# Advisory – PCN UPDATE

**SUBJECT:** *POD update related to PCN SIL-0092017*

## TO-220 FULLPAK (High Voltage)

OPTION 1: FACILITY CODE = 9

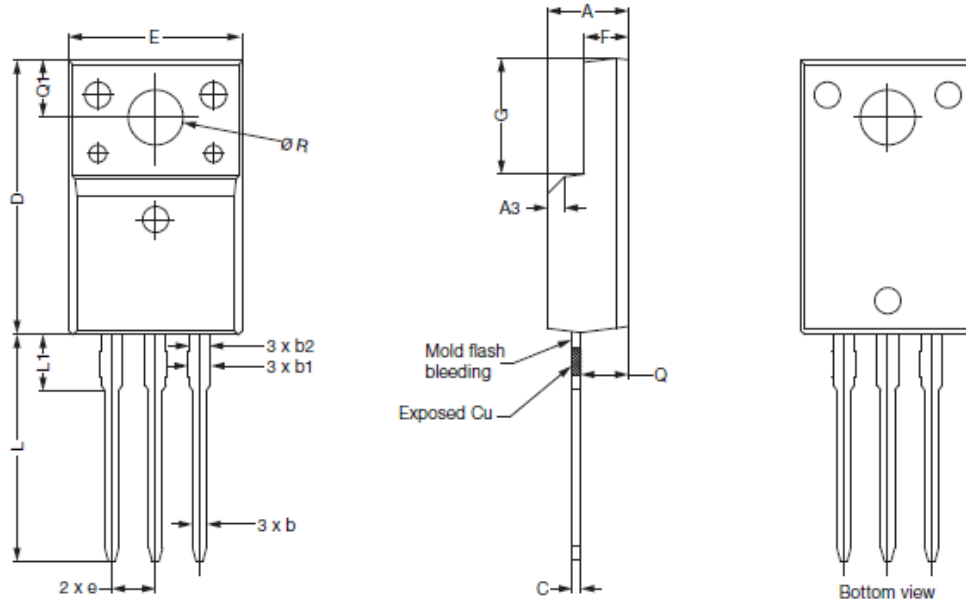
This advisory is being provided to you as an announcement that when the subject PCN was issued on July 18, 2017 for additional commercial Power Mosfet manufacturing capacity at GEM Electronics for Vishay's TO-220 Full-Pack package, the document did not articulate some of the differences for the dimensions as the GEM version of the package is slightly different.

The updated POD drawing is below for your reference. We have already started the process to update the POD/package dimensions on all our documentation including the Vishay website.

POD from GEM Electronics:

## OPTION 2: FACILITY CODE = Y

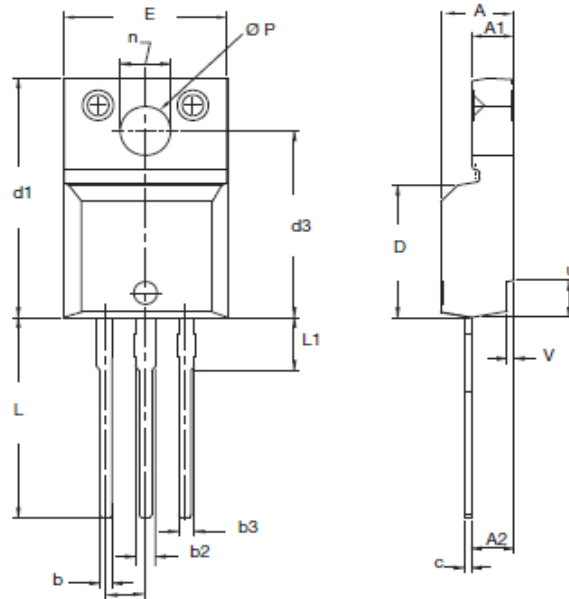
POD from Vishay Xian:
